# MIAMI BEACH

### Design Review Board

SUBJECT: DRB20-0577 (aka DRB17-0216 DRB17-0160)  
**1420-1508 Bay Road—The Grand Flamingo**

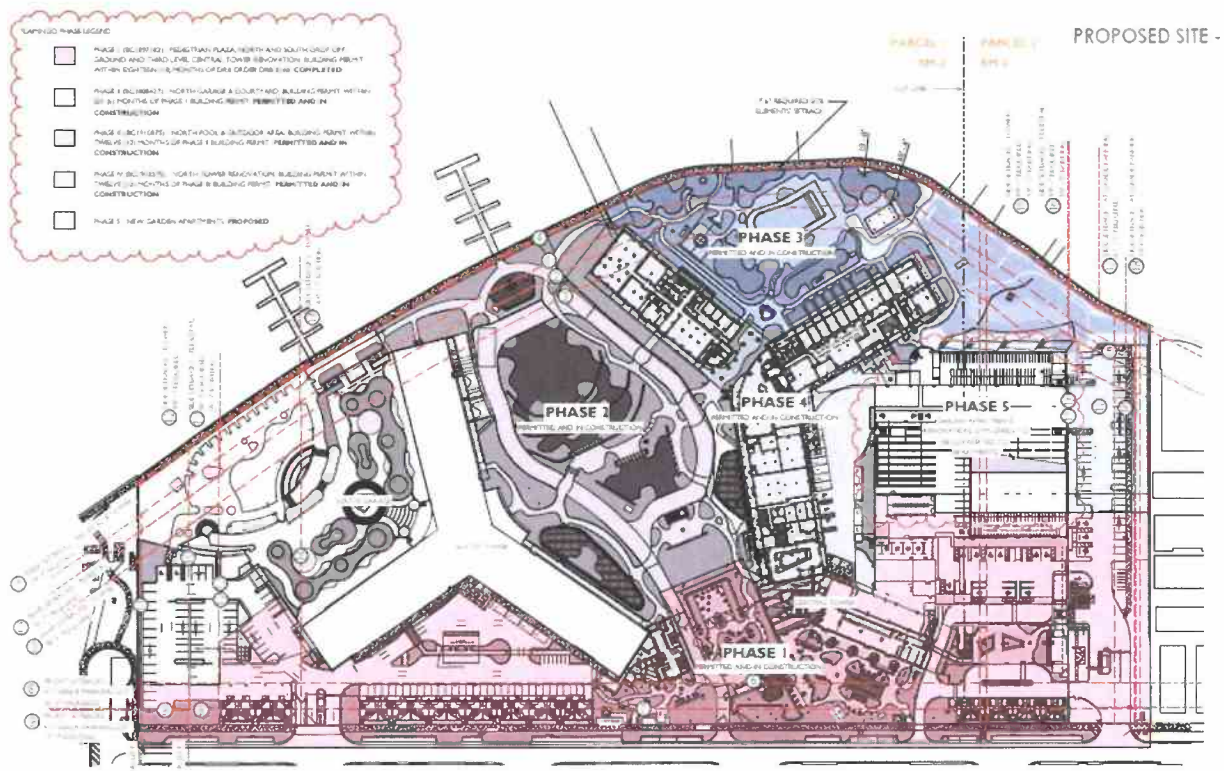
As construction continues at the expansive site, field conditions determine certain necessary modifications to the proposed plans. The applicant proposes further refinements to the exterior bay-facing elevations of the North Tower, as well as the proposal to convert the accessory gym on the upper floors of west side of the North Garage into 8 new garden apartments with prime views of Biscayne Bay, which will be included as Phase V. The proposed modifications to the elevations concern mainly the short façade ends of the north

and west wings of the North Tower. The previous approved design had facades with a central band of glazing, flanked by balconies, that ran up the entirety of the building and which was crowned with a framed architectural element. The new elevations have replaced the glazing with a band of fluted stucco, a common detail on elevation, that terminates beyond the roof line as an accentuated parapet, completed removing the architectural frame beyond the roof line. The new garden apartments will be similar to those on the floors below, as will the fenestration facing Biscayne Bay.
